2019-05-29

Subject: 91 and 131 Eglinton Avenue East, and 5055 Hurontario Street Transportation Study - Response to Comments

A Transportation Study was completed by WSP for the subject lands in September 2018 along with a Technical Memo regarding the Belbin Street extension, dated June 2018. Subsequently, comments were received from the City of Mississauga, dated February 6th, 2019, which are provided in **Attachment 1**. WSP discussed the transportation comments with the City on March 16, 2019 and the approach for addressing them. The brief synopsis of the discussion is provided in **Attachment 2**. All comments directly related to the September 2018 Transportation Study and June 2018 Technical Memo, as well as comments regarding waste collection (below in red) have been addressed within this letter. The contents of this letter are based on the latest site plan, dated April 24th, 2019, which is provided as **Attachment 3**.

Figure 1
Peel Region Front Loading Garbage Truck Accessing Loading/Garbage Pick-Up Area, Phase 1
91 Eglinton Avenue East

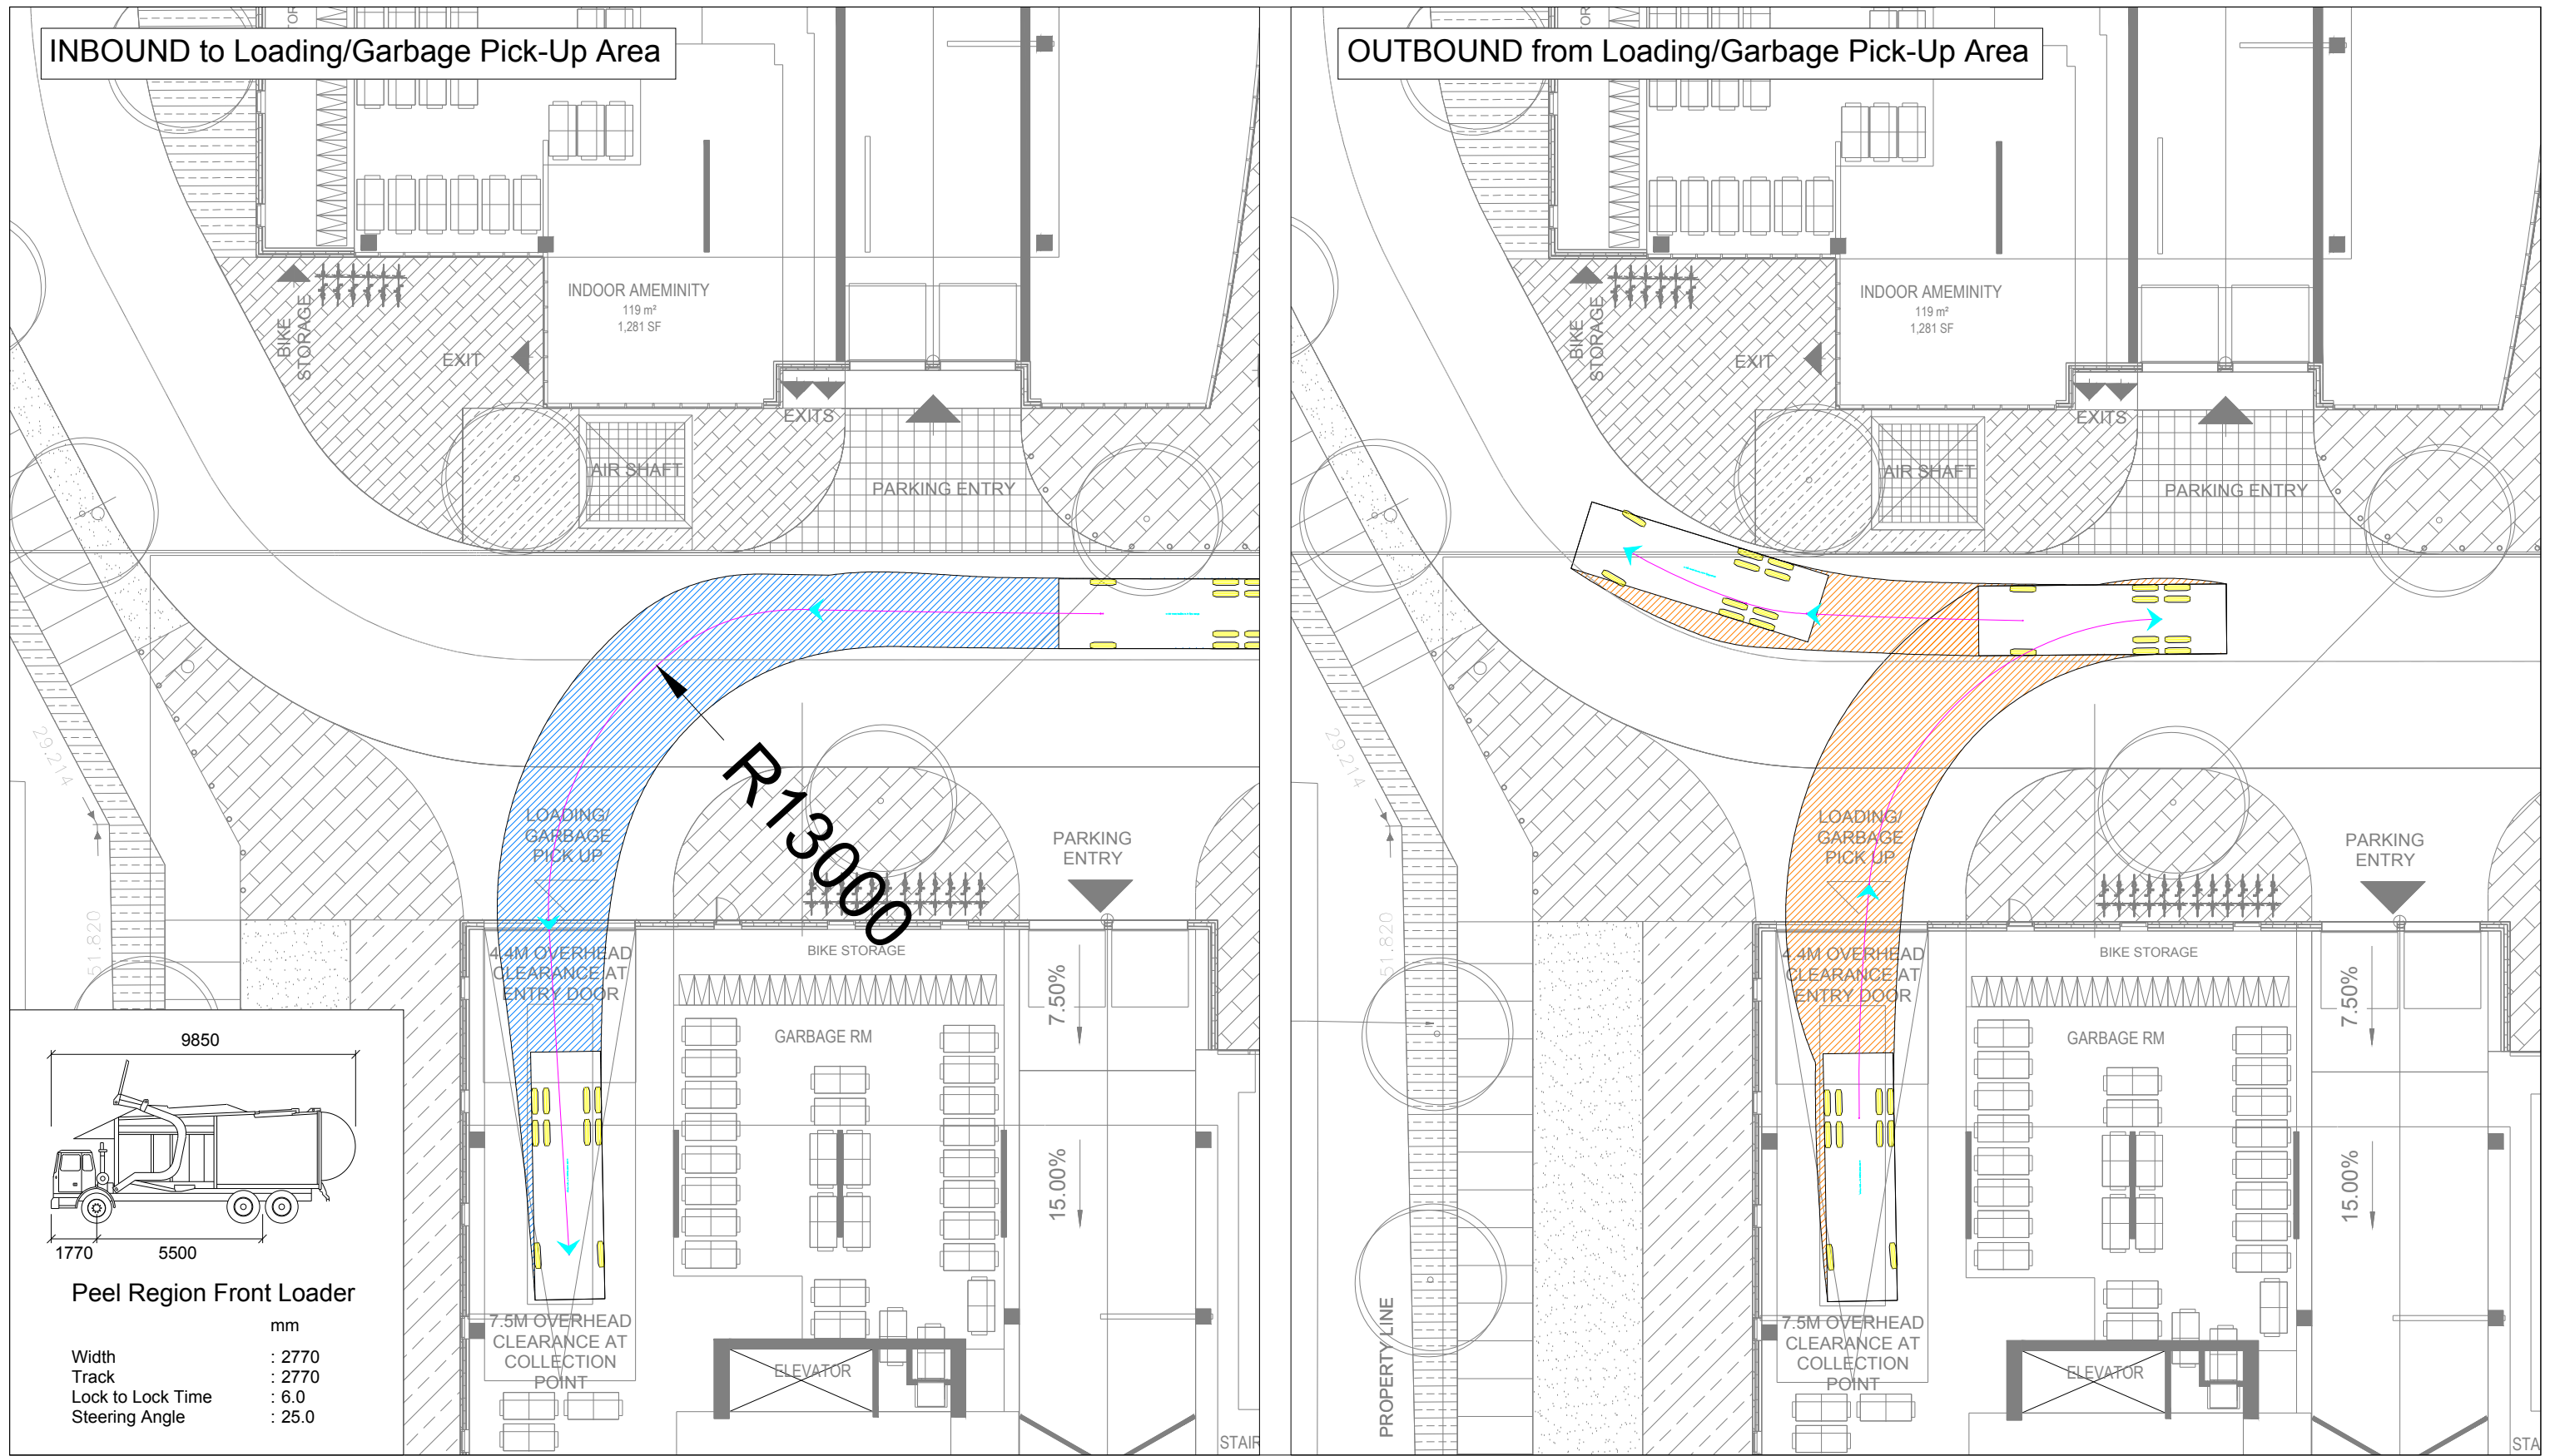
3. The movement of garbage and service vehicles is not to Regional Standards and not supported by Urban Design. (Page 12)

The garbage collection loading spaces for the condominium towers were assessed using the front-end bin loading waste collection vehicle specifications within Appendix 1 of the Region of Peel Waste Collection Design Standards Manual. The garbage collection areas for the townhouses were assessed using the side-loading cart waste collection vehicle specifications. In addition, the following design requirements are specified in the Region's Standards:

- All roads shall be designed to have a minimum width of 6 metres;
- The turning radius from the centerline must be a minimum of 13 metres on all turns; and
- The waste collection vehicle shall not be permitted to back-up onto a municipal road allowance.

and centerline curb radii exceeding the requirements from Peel Region Waste Management. The vehicle maneuvering for the condominium loading spaces, the curb-side collection for the townhouses, and the internal turning radii assessment diagrams are provided in **Attachment 5** as follows:

- Figure 1 – Figure 4: Garbage Truck Maneuvering for Condominium Loading Spaces;
- Figure 5: Garbage Truck Maneuvering for Curb-Side Collection of Townhouses; and
- Figure 6: Internal Circulation Turning Radii Assessment (Phase 1, 2 and 3)

Figure 7
Site Pedestrian Facilities with Pavement Markings and Signage
91 Eglinton Avenue East

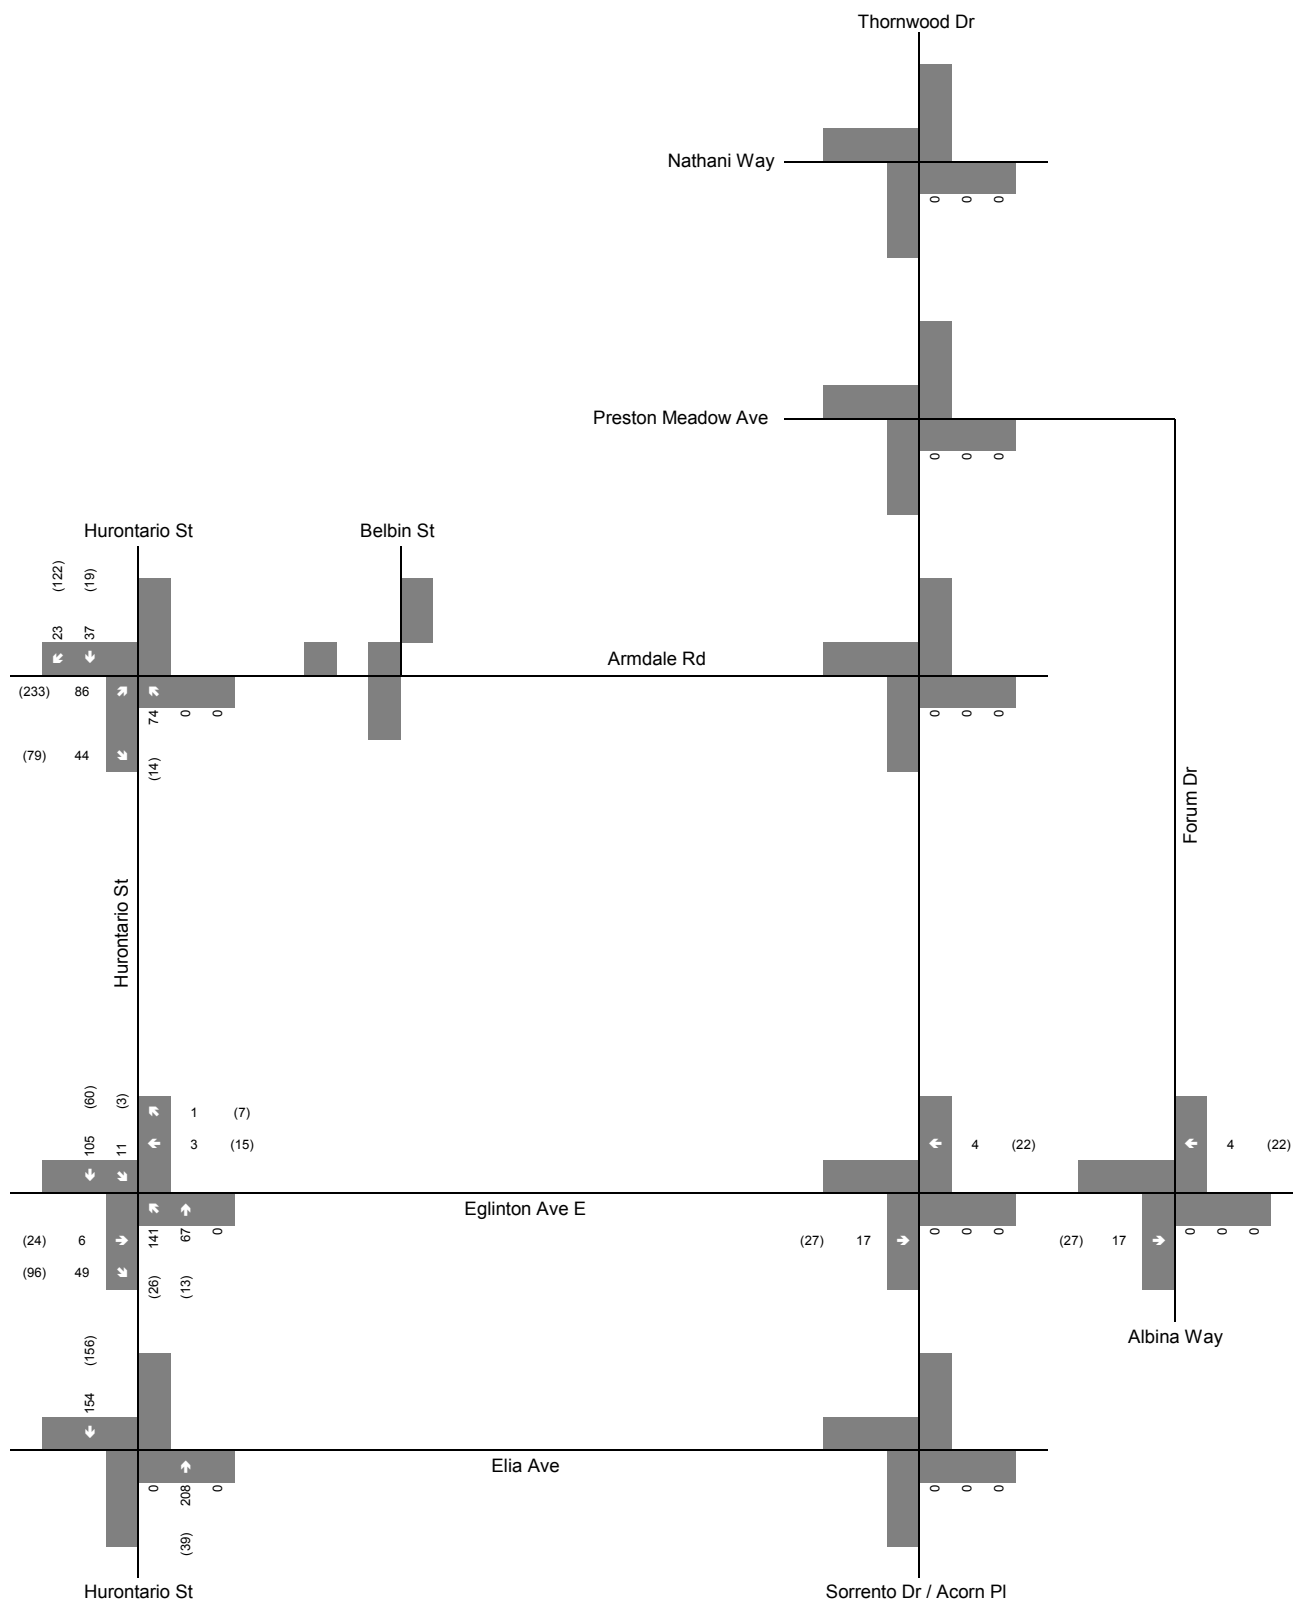
7. *Pedestrian Walkways - Provide greater emphasis on pedestrian safety throughout the plan. Consider defined pedestrian crossings at all intersections and emphasize safe movement throughout the site. Further detail is needed to design pedestrian and vehicular areas to create a safe environment maintaining the curbless design. Please demonstrate how pedestrian areas will be differentiated from vehicular areas and how pedestrian crossing area will be articulated. (Page 14)*

The applicant is to ensure convenient and safe pedestrian linkage is provided within the development site, specifically connecting pedestrians from Tower A/B/G to the proposed public park through the use of pavement markings, signage and the Ontario Traffic Manual - Book 15;

Figure 7 of Attachment 5 illustrates the proposed pedestrian connections such as sidewalks and crosswalks provided on-site. Crosswalk markings are proposed to be added to the north leg of the intersection of Thornwood Avenue at Eglinton Avenue to be consistent with OTM Book 11, Figure 32 and the existing crossings at the remaining three legs of the intersection. Crosswalk markings are also proposed at the all-way stop intersection of Thornwood Avenue and Armdale Road to be consistent with the pedestrian crossing treatment shown in Figure 48 of OTM Book 15. A mid-block pedestrian crossover Level 2 Type D, consistent with OTM Book 15, Figure 42 is proposed within the site to provide a pedestrian connection for Towers A and B to the outdoor amenity and public park. A Crossride facility, consistent with OTM Book 18, Figure 4.103 is proposed for the proposed Multiuse Path (MUP) crossing the future Armdale road. The sidewalks and drive aisles within the development would be finished in pavers of different textures to provide a pedestrian friendly environment and differentiation to vehicular space. In addition, Towers A, B, D, and E will all be connected to the public park via walkways on the concourse level, provide a grade separated and sheltered pedestrian connection between those buildings and to the park.

As the intersection of Thornwood Drive and Armdale Road will be all-way-stop controlled, crosswalk at the intersection will provide pedestrian connection between Tower G and the proposed park, as well as from Tower G to Tower D. Pedestrian connection between Tower A/B and the proposed park will be provided by a proposed mid-block crosswalk situated in front of the drop-off entrance. Based on the evaluation criteria provided in Figure 2 of the Ontario Traffic Manual (OTM) Book 15, a crosswalk is recommended at this location as it on the pedestrian desire line given the proximity of the entrance to the public green space to the north. The crosswalk will be constructed to the specification of a Level 2 Type D crosswalk as illustrated in Figure 42 of the OTM Book 15 based on the expected vehicular volume and the selection criteria shown in Table 7 of the OTM Book 15. Tower A/B and Tower G will also be connected by pedestrian crosswalk at the Eglinton Avenue East and Thornwood Drive intersection. Finally, Towers A, B, D, and E will all be connected to the public park via walkways on the concourse level, provide a grade separated and sheltered pedestrian connection between those buildings and to the park.
